Department of Energy  
Carlsbad Area Office  
P. O. Box 3090  
Carlsbad, New Mexico 88221

June 26, 2000

[PLANS TO RAISE THE REPOSITORY HORIZON] Aug 2/6/04

The purpose of this letter is to inform the Environmental Protection Agency that the Carlsbad Area Office (CAO) plans to raise the repository horizon in Panels 3, 4, 5 6, and 9 by approximately two meters so that the roof is at clay seam G. The Waste Isolation Pilot Plant intensively monitors the geomechanical behavior of its underground excavations. Actual monitoring of underground excavations, specific underground studies, and geotechnical modeling (e.g., DOE-WIPP 94-025, Investigation of the Advantages of Removing Highly Fractured Roof Beams), all demonstrate that positioning the roof at clay seam G improves ground conditions in the repository and provide a more stable roof configuration without significantly impacting repository performance. Raising the repository horizon reduces the rate at which ground deteriorates (i.e., slower roof beam deformation rate and slower development of fractures), thus reducing risks during mining and waste handling operations.

Figure 3-2. Plan View of WIPP Underground Facility and Panel Closure Systems

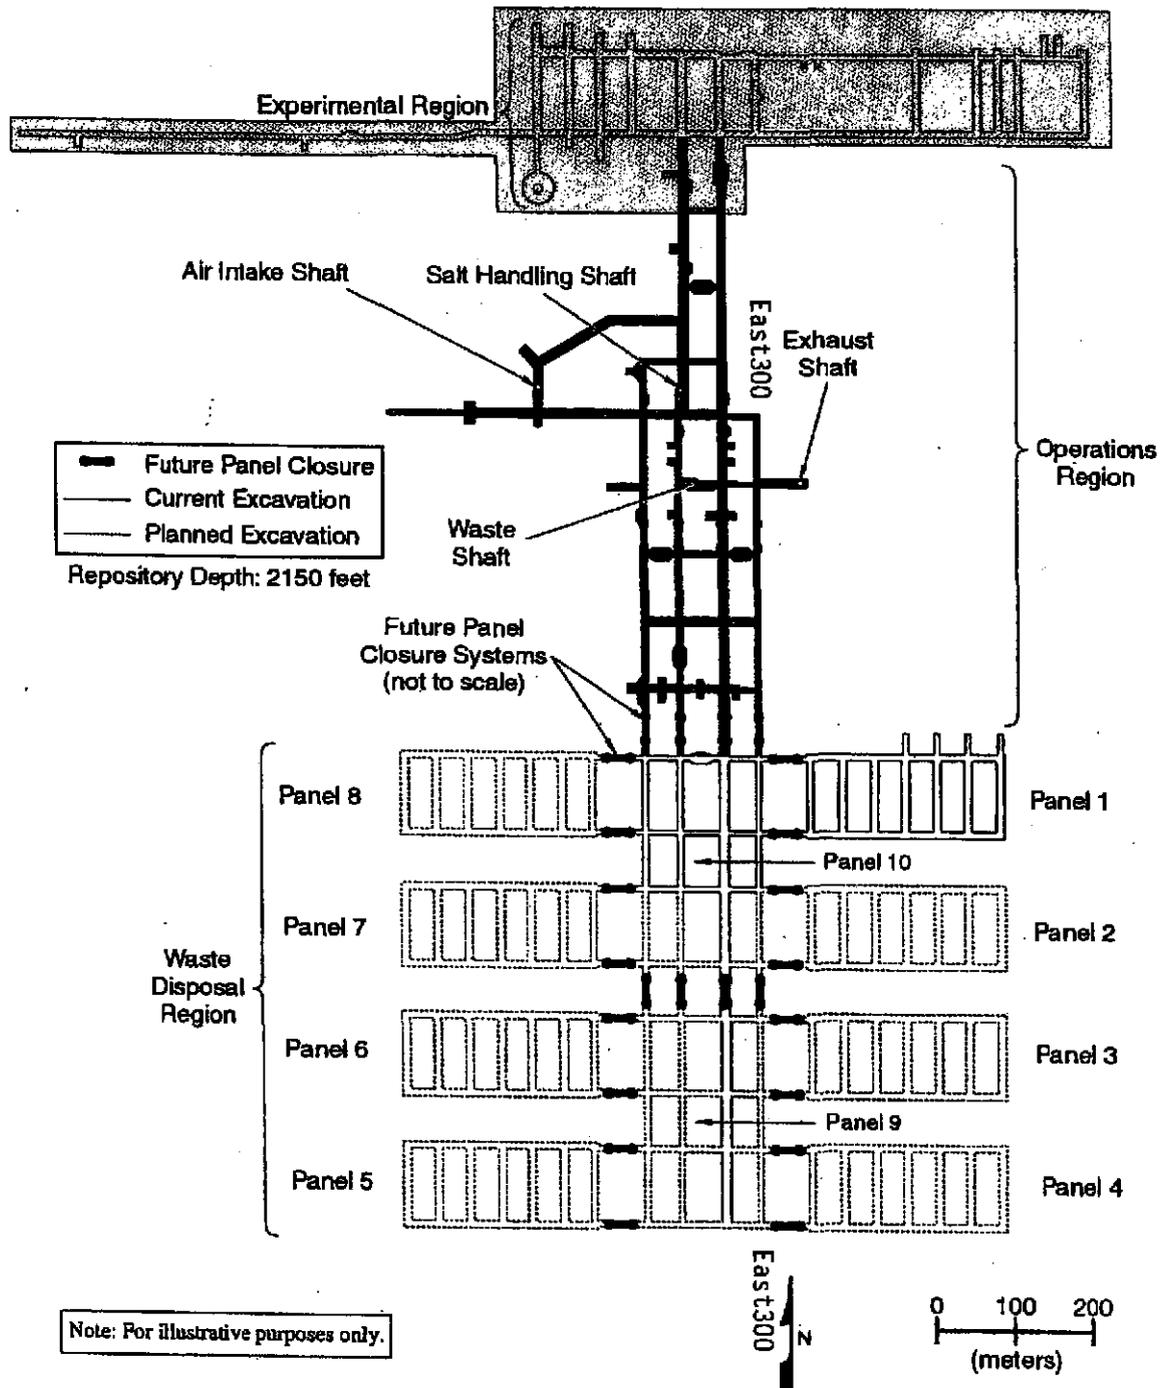
The repository horizon for Panels 3, 4, 5, 6, and 9 will be raised so that the roof is at clay seam G (shown on the attached Figure 3-6). Raising the repository horizon will be initiated in the East 300 drift (shown on the attached Figure 3-2) which leads into Panel 3. Raising the repository horizon now and in this location will result in improvements in safety and in operational efficiencies. This does not imply that there are underground safety concerns associated with the present situation; however, by raising the repository horizon by about two meters, ground conditions will be improved and considerably less maintenance will be required to assure optimum ground conditions.
